13023 Greenwood Avenue North DPD# 3004905

Foss Home and Village

Dec. 10 . 07

1 WIDTH - DEPTH ANALYSIS
1" = 30'-0"

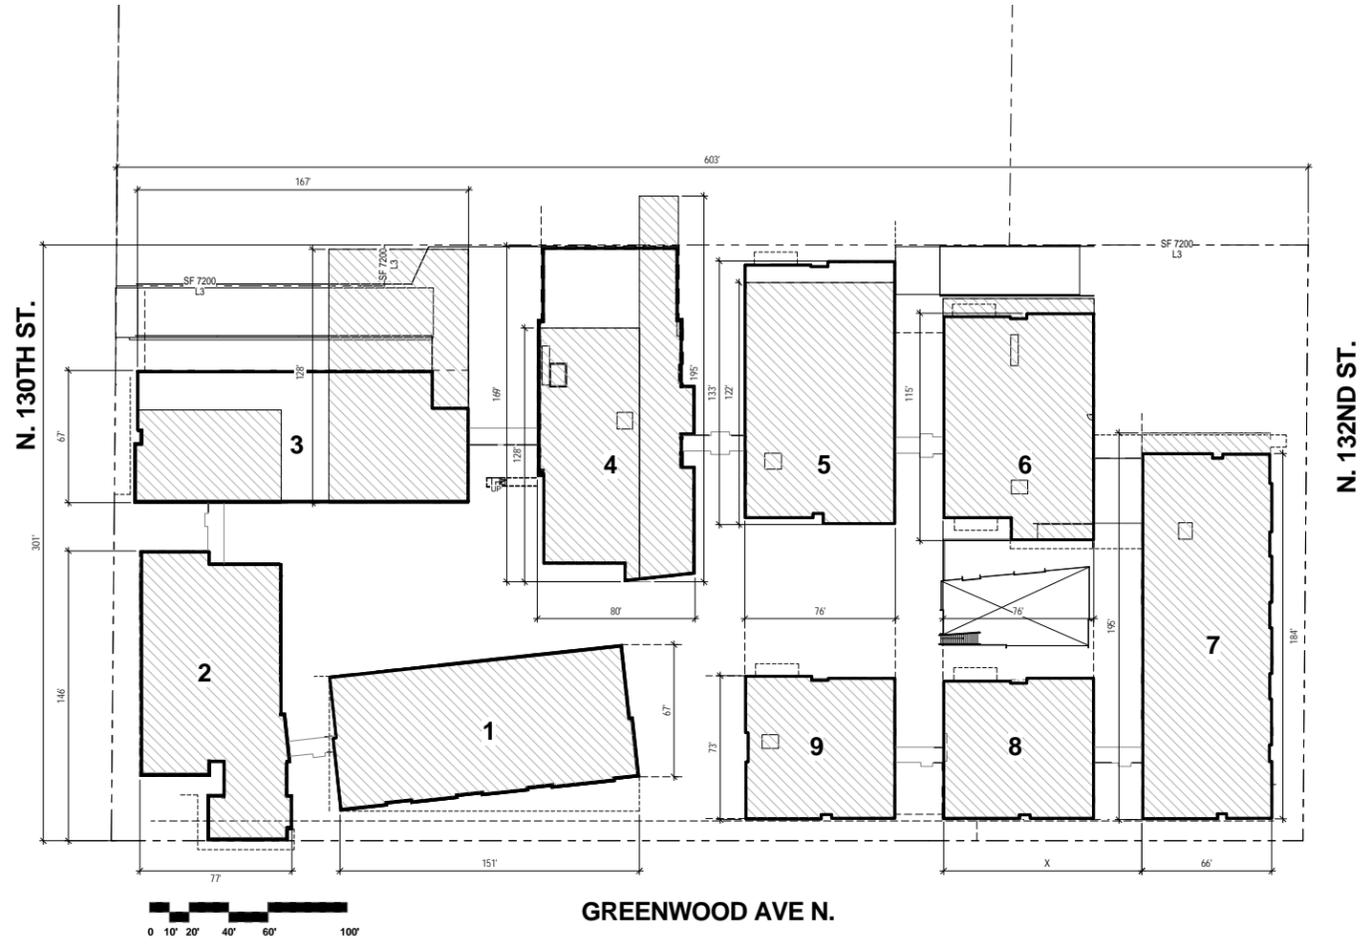
Section 4 - Building width and depth

As stated in the discussion above, this is a large site that is wrapped on three sides with streets. One of the consequences of this configuration is that the corner buildings have two sides exposed that are calculated for building width/depth. Inevitably one of these sides will not measure within the prescriptive definition on the land use code. Perhaps a better way of evaluating the appropriateness building depth is to add up the cumulative building depths and compare it to the potential allowed under the code. In this case the allowed cumulative depth (adding up the number of depths x 195 feet) is 1170 feet. The proposed cumulative depth is 1161 feet.

DEPTH	BLDG 2 / 3 ALLOWABLE 195' PROPOSED 213'	BLDG 1 / 3 ALLOWABLE 195' PROPOSED 134'	BLDG 1 / 4 ALLOWABLE 195' PROPOSED 236'	BLDG 9 / 5 ALLOWABLE 195' PROPOSED 206'	BLDG 8 / 6 ALLOWABLE 195' PROPOSED 188'	BLDG 6 / 7 ALLOWABLE 195' PROPOSED 254'
WIDTH <small>* WITH MODULATION</small>	BLDG 2 ALLOWABLE 75' PROPOSED 77'	BLDG 1 ALLOWABLE 75' PROPOSED 151'	BLDG 4 ALLOWABLE 75' PROPOSED 80'	BLDG 5 ALLOWABLE 75' PROPOSED 76'	BLDG 8 ALLOWABLE 75' PROPOSED 76'	BLDG 6 / 7 ALLOWABLE 75' PROPOSED 66' + x
	BLDG 3 ALLOWABLE 75' PROPOSED 167'			BLDG 9 ALLOWABLE 75' PROPOSED 76'

BLDG 7/8/9

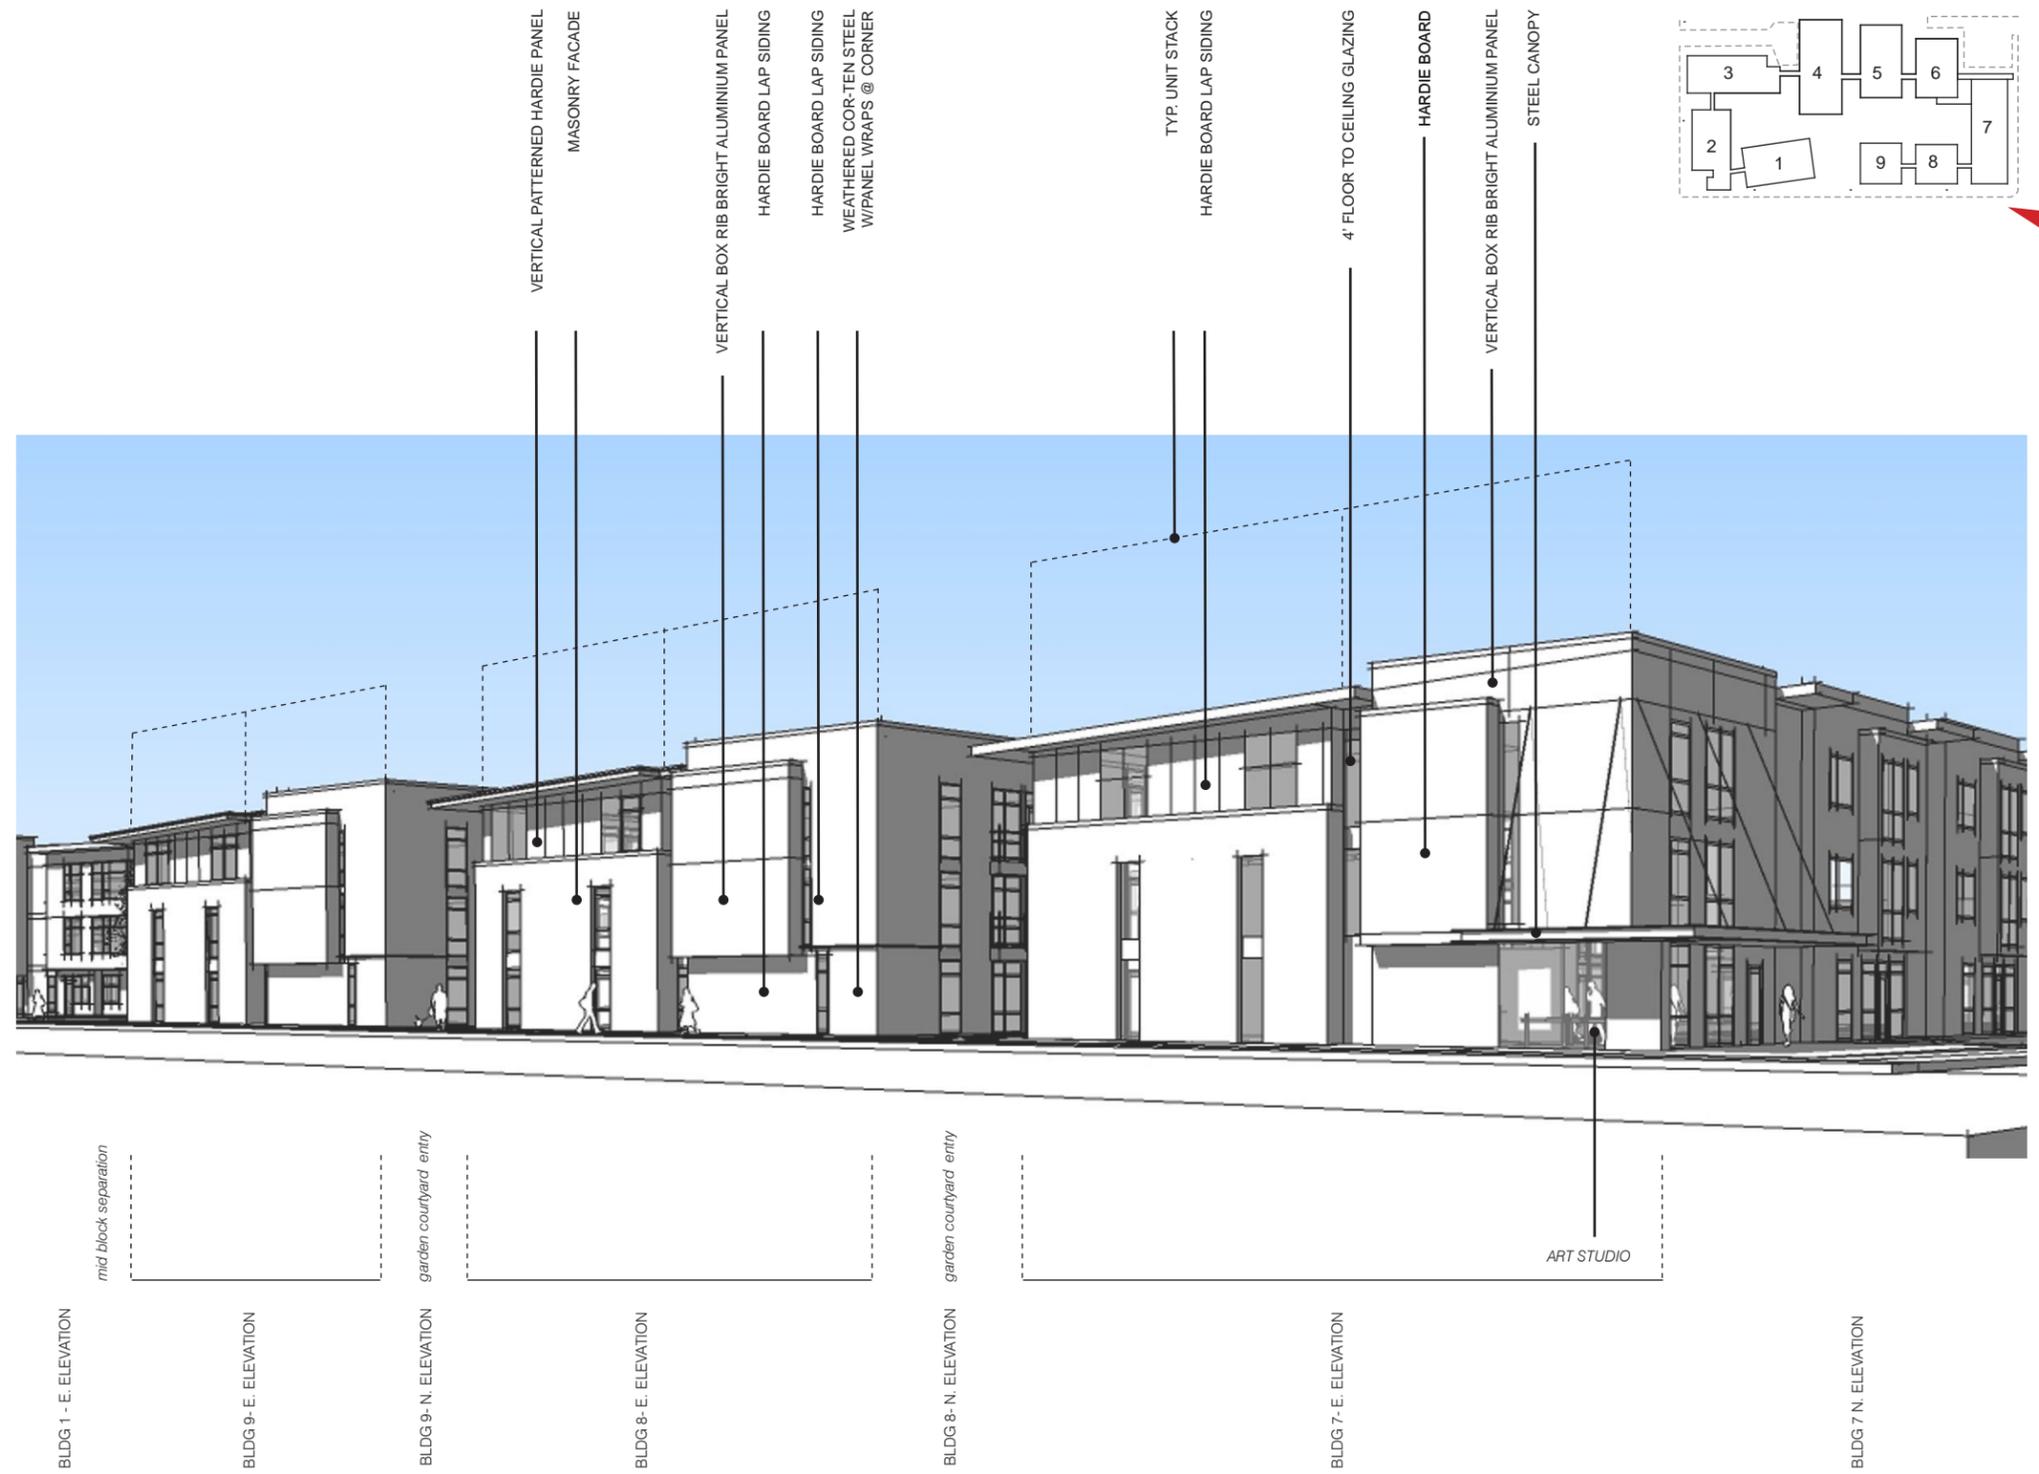
Provide a design alternative which includes code-compliant modulation.	Applicant has provided a narrative stating that the design intent of the Code is exhibited through the provided design.	Mithun must provide graphics of of an alternative which features code-complying modulation.	Yes - Mithun shall include graphics of a design alternative which features code-complying modulation.	Mithun must clearly identify any and all requested departures, to illuminate deficiencies with regard to code-compliance. Mithun must include a code-complying alternative in the packet, which will also bolster the applicant's stance that the preferred design upholds the Code intent.	A modulation analysis has been included. It describes the basic perscriptive compliance model and compares it to the proposed.
		Landscaped open-space, specifically generous setbacks, provide a way to reduce the bulk and scale of the development.	Applicant has responded that the Code does not require open space to be dedicated for public use or for buffering the public view from the built project. Mithun has reiterated that the open space creates a sense of scale and density.	Mithun should investigate ways to enhance the mid-block corners along Greenwood, and options for landscaping the setbacks along street frontages.	Yes - options should be investigated and included in packet	Mithun has indicated that the proposed central courtyard and proposed open space advance the sense of scale and density desired in this urban setting. Mithun should still investigate ways to further enhance the mid-block corners and generous setbacks, and incorporate enhancements into the packet.	Scale and Bulk have been considered in the developed design.

alternative modulation

Articulation of contextual neighborhood residential scale, texture, and unit delineation is enhanced using a variety of roof edges, facade materials/colors, bays, and grade level patio entries.
